HABITAT ARCHITECTURAL REVIEW BOARD

TABBY ROADS

July 30, 2024

This letter shall serve as approval with conditions for the planned single family residence build on 34 Tabby Shell Rd. Please note that some of the conditions in this letter might need to be incorporated prior to final HPC submission. Plans within the following files titled are the basis for this approval:

Fig 1. – Post Depiction Clarification

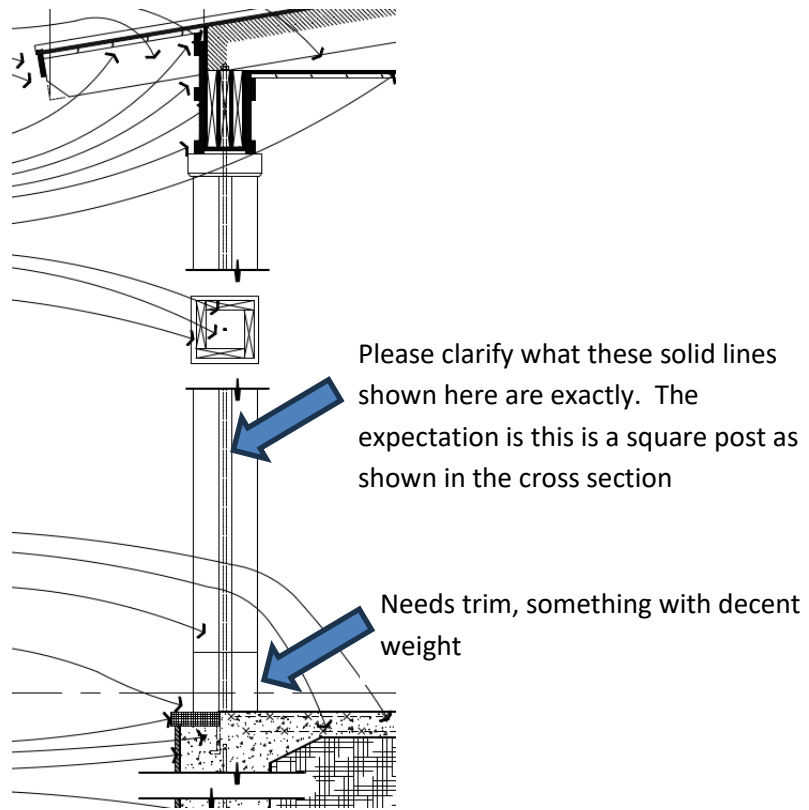
- At the base of the front posts, trim must be added that complements the upper trim out of the posts. The committee felt the lack of trim was out of balance to this presentation and “architectural weight” was needed down low.
- Clarification of the “vertical lines” shown on post in Fig 1 is required. From the cross section, all posts appear as simple wrapped rectangular sections with seams near the corners, so it is unclear what the solid vertical lines are representing.

Fig 2. – False Window Suggestion

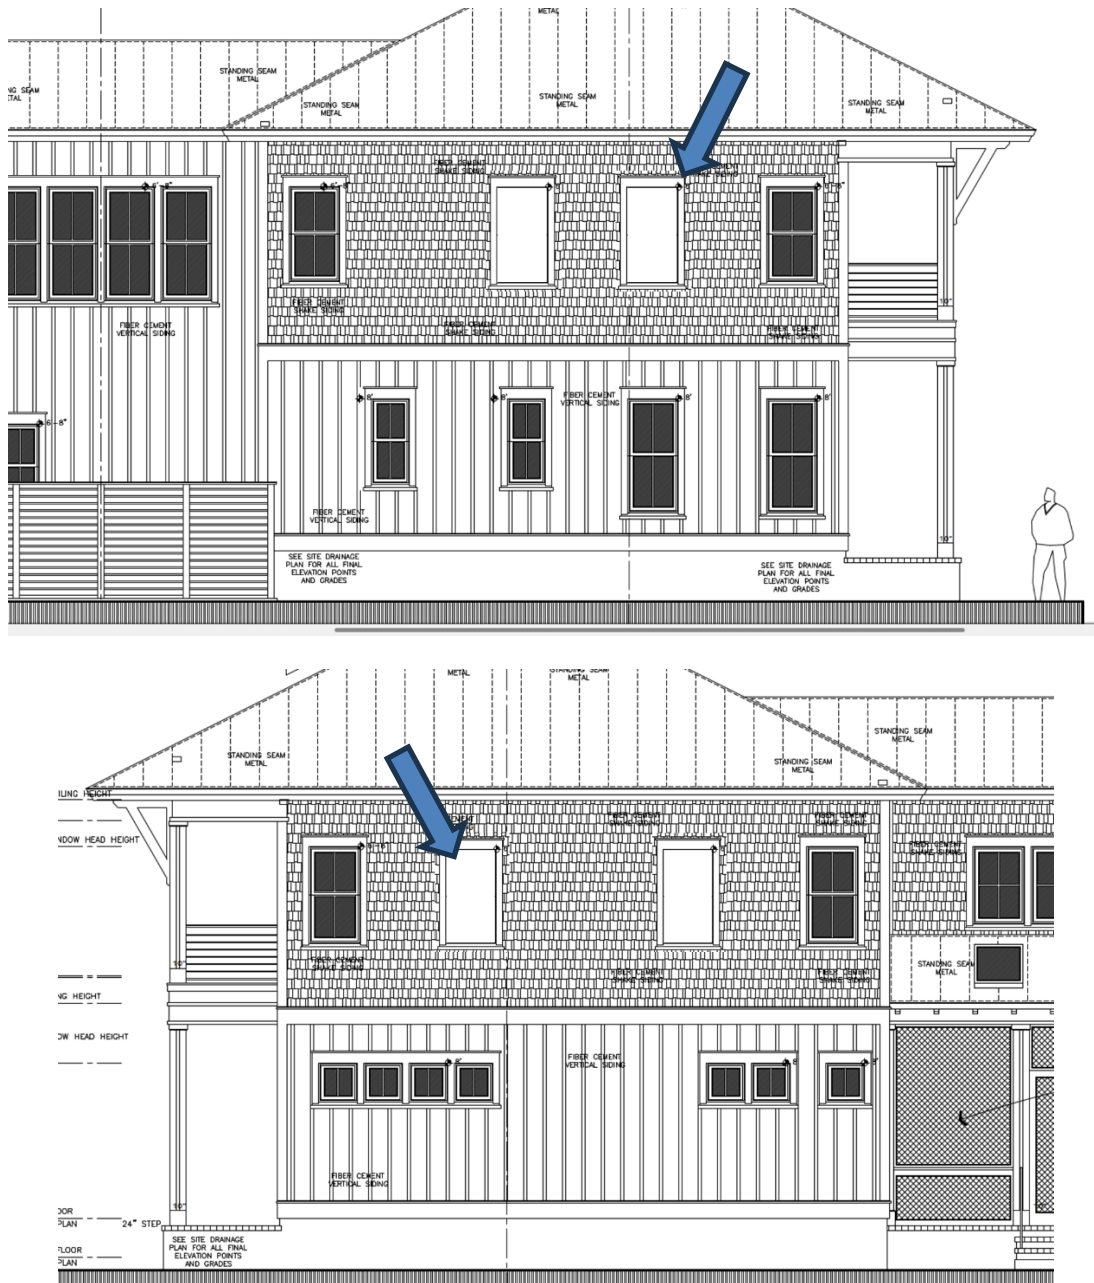
- The committee would like the applicant to consider "false window" trim out or some other similar architectural detail like shown in Fig 2. to break up the large expanse of siding on both side elevations.
